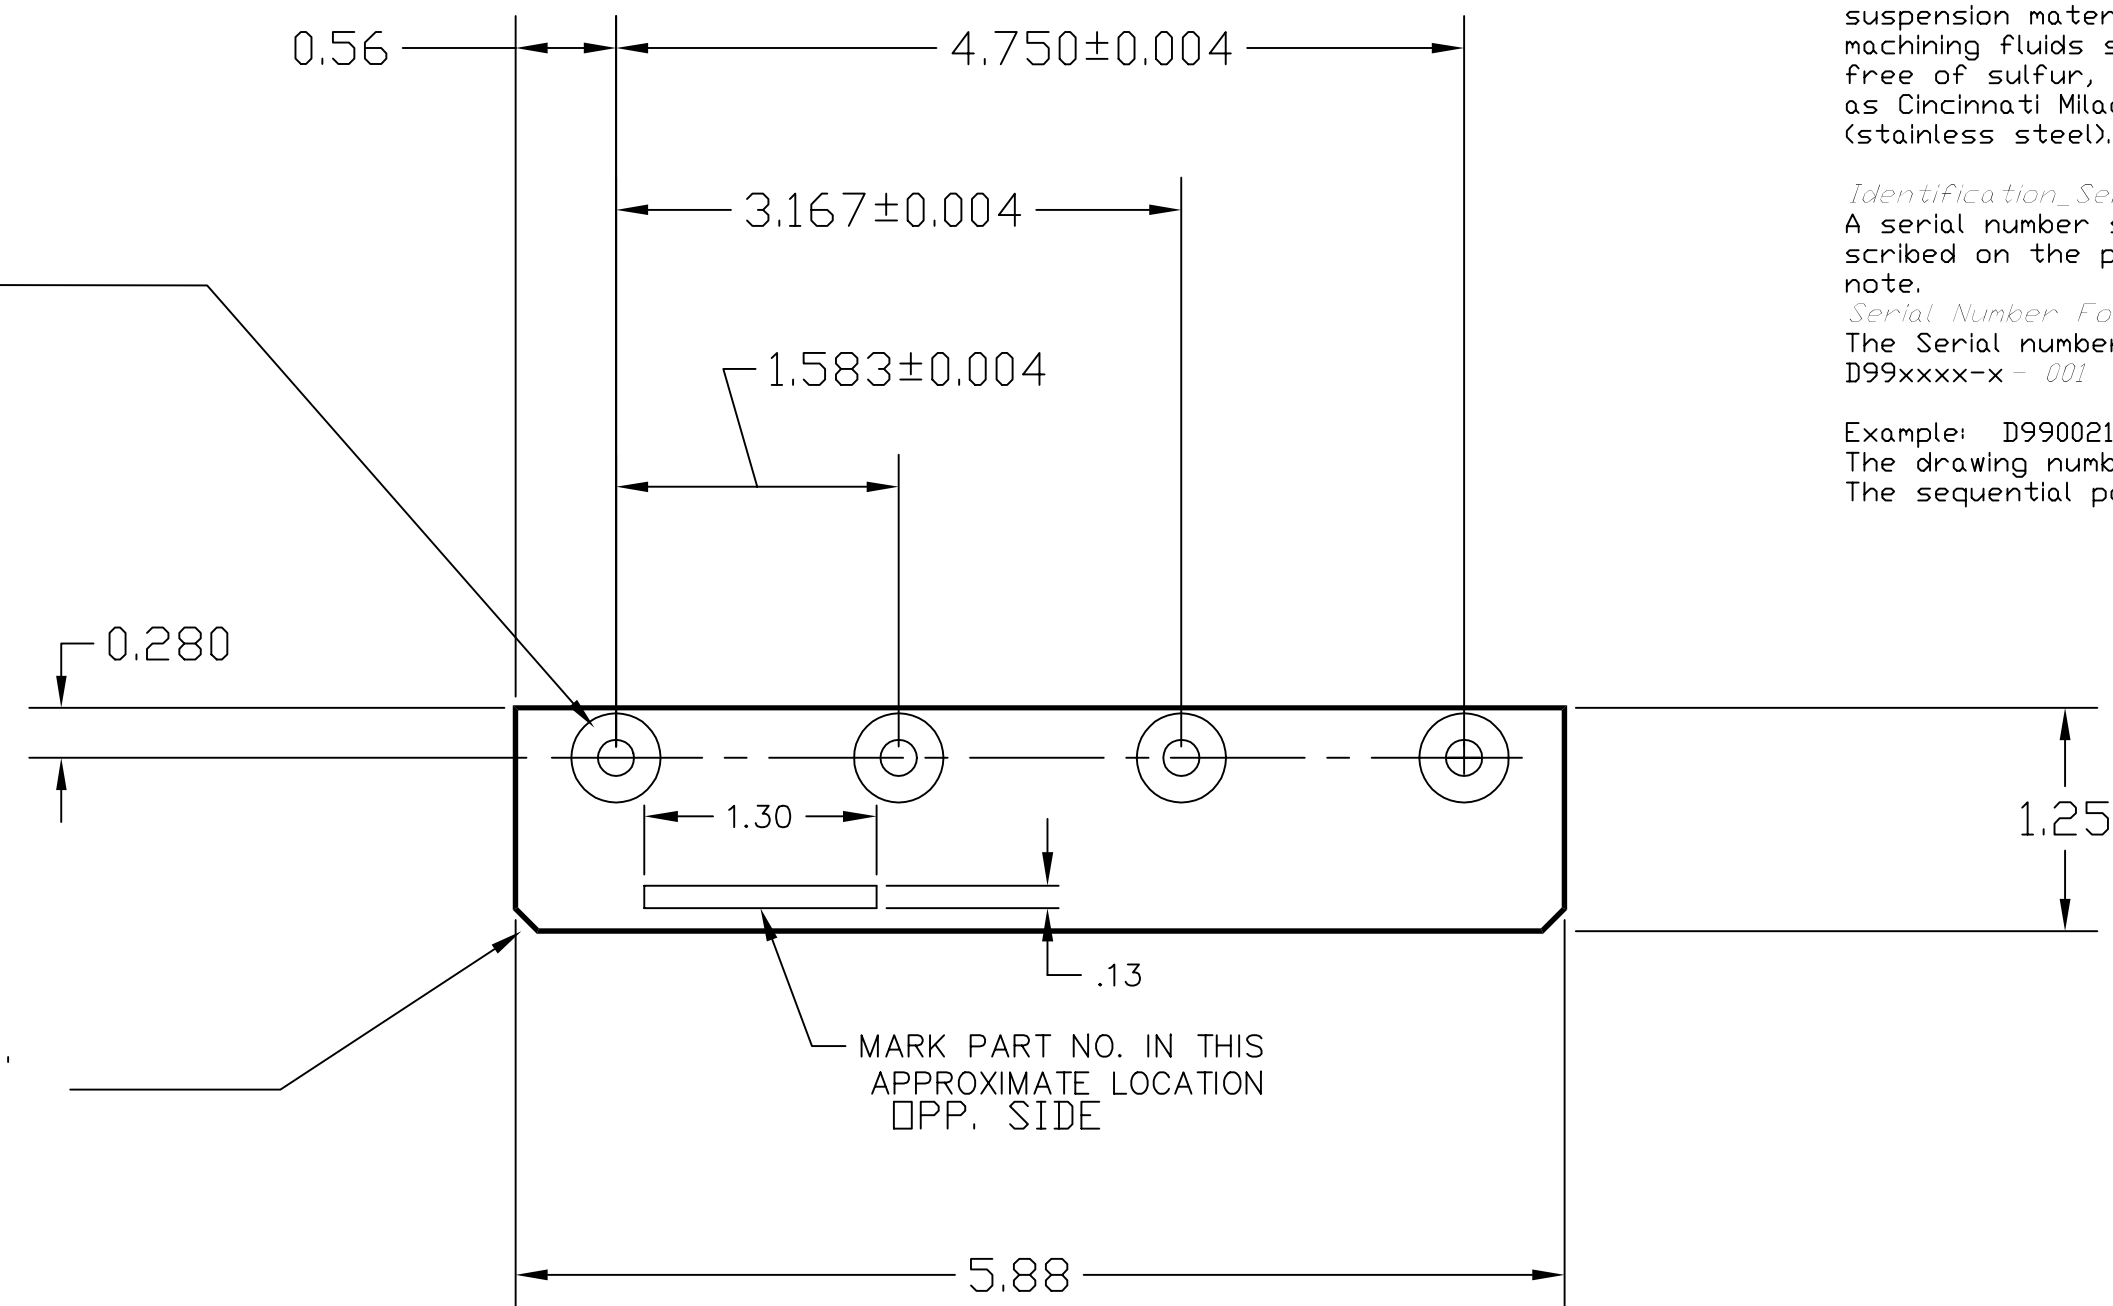
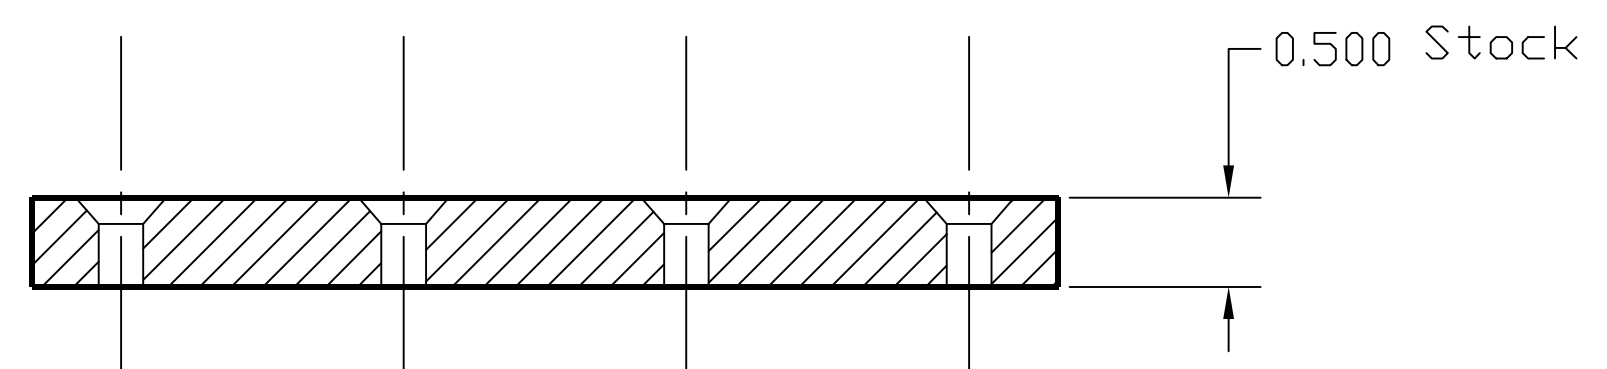
~~Liquid contaminants/Machining Lubricants~~
 Liquids containing hydrocarbons or other contaminants, other than the machining fluids specified herein, shall not be allowed to come into contact with suspension material at any time. All machining fluids shall be water soluble and free of sulfur, chlorine and silicone; such as Cincinnati Milacron's Cimtech 410 (stainless steel).
